UNITED STATES PATENT AND TRADEMARK OFFICE

09/990,498

Office Action Summary

DETAILED ACTION

FIG. 2a

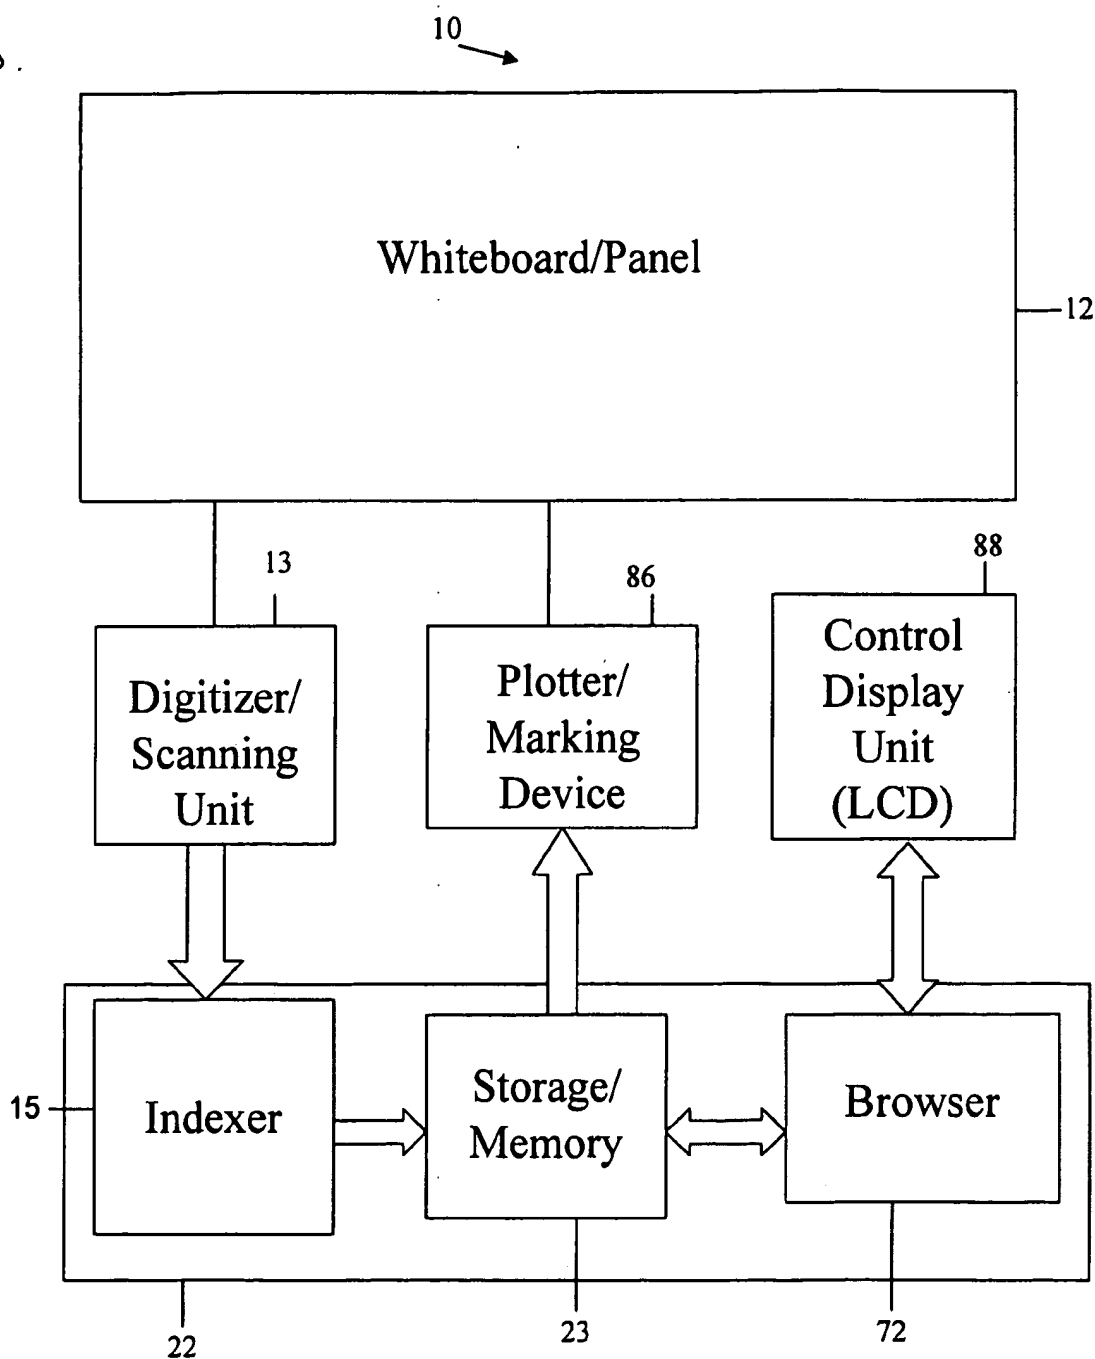
3. The drawings were received on 02/27/2006. These drawings are not acceptable because Fig. 2a introduces new matter. See the specification objection above.

DISAPPROVED.
JHN
5/5/06
